**Economic Commission for Europe****Inland Transport Committee****World Forum for Harmonization of Vehicle Regulations****Sixty-first session**

**Regulation No. 129 (Enhanced Child Restraint Systems)****Proposal for Supplement 3 to the 01 series of amendments to Regulation No. 129****Submitted by the expert from France\***

Figure 1.

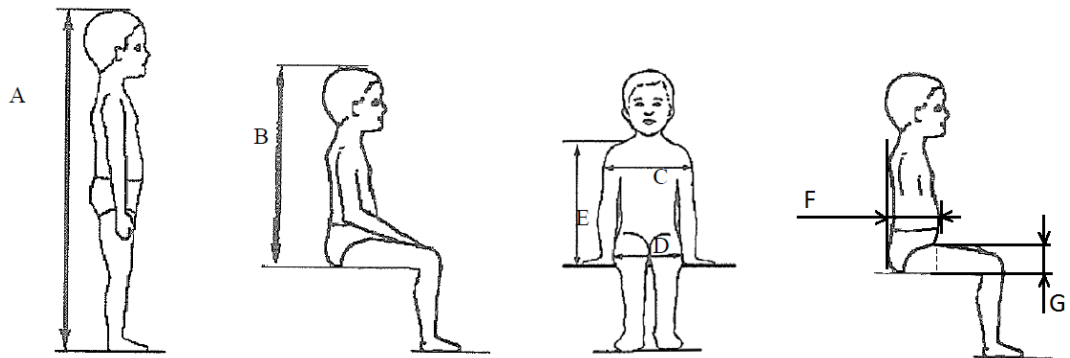
Annex 18, amend to read:

### Geometrical dimensions of Enhanced Child Restraint Systems

<i>Min</i>	<i>Min</i>	<i>Min</i>	<i>Min</i>	<i>Max</i>	<i>Min</i>	<i>Max</i>		<i>Minimum</i>	<i>Minimum</i>
<i>Stature</i>	<i>Sitting height cm</i>	<i>Shoulder breadth cm</i>	<i>Hip breadth cm</i>	<i>Shoulder height cm</i>	<i>Shoulder height cm</i>	<i>Abdomen depth cm</i>	<i>Abdomen depth cm</i>		<i>Upper leg thickness cm</i>	<i>Upper leg thickness cm</i>
A	B	C	D	E1	E2	F1	F2		G1	G2
	95%ile	95%ile	95%ile	5%ile	95%ile	5%ile	95%ile		5%ile	95%ile
40	NA	NA	NA	NA	NA	NA	NA		NA	NA
45	39.0	12.1	14.2	27.4	29.0	NA	NA		NA	NA
50	40.5	14.1	14.8	27.6	29.2	NA	NA		NA	NA
55	42.0	16.1	15.4	27.8	29.4	NA	NA		NA	NA
60	43.5	18.1	16.0	28.0	29.6	NA	NA		NA	NA
65	45.0	20.1	17.2	28.2	29.8	NA	NA		NA	NA
70	47.1	22.1	18.4	28.3	30.0	NA	NA		NA	NA
75	49.2	24.1	19.6	28.4	31.3	<b>12.5</b>	<b>15.1</b>		<b>5.7</b>	<b>8.4</b>
80	51.3	26.1	20.8	29.2	32.6	<b>12.7</b>	<b>15.7</b>		<b>5.8</b>	<b>8.4</b>
85	53.4	26.9	22.0	30.0	33.9	<b>12.9</b>	<b>16.2</b>		<b>5.9</b>	<b>8.5</b>

90	55.5	27.7	22.5	30.8	35.2	<b>13.1</b>	<b>16.8</b>		<b>6.2</b>	<b>8.5</b>
95	57.6	28.5	23.0	31.6	36.5	<b>13.3</b>	<b>17.8</b>		<b>6.5</b>	<b>8.9</b>
100	59.7	29.3	23.5	32.4	37.8	<b>13.5</b>	<b>18.2</b>		<b>6.5</b>	<b>9.6</b>
105	61.8	30.1	24.9	33.2	39.1	<b>13.6</b>	<b>18.8</b>		<b>6.6</b>	<b>10.3</b>
110	63.9	30.9	26.3	34.0	40.4	<b>13.9</b>	<b>19.6</b>		<b>6.6</b>	<b>10.3</b>
115	66.0	32.1	27.7	35.5	41.7	<b>13.9</b>	<b>19.9</b>		<b>6.6</b>	<b>10.4</b>
120	68.1	33.3	29.1	37.0	43.0	<b>14.3</b>	<b>20.2</b>		<b>6.8</b>	<b>10.5</b>
125	70.2	33.3	29.1	38.5	44.3	<b>14.7</b>	<b>20.7</b>		<b>7.5</b>	<b>10.9</b>
130	72.3	33.3	29.1	40.0	46.1	NA	NA		NA	NA
135	74.4	33.3	29.1	41.5	47.9	NA	NA		NA	NA
140	76.5	34.2	29.6	43.0	49.7	NA	NA		NA	NA
145	78.6	35.3	30.8	44.5	51.5	NA	NA		NA	NA
150	81.1	36.4	32.0	46.3	53.3	NA	NA		NA	NA
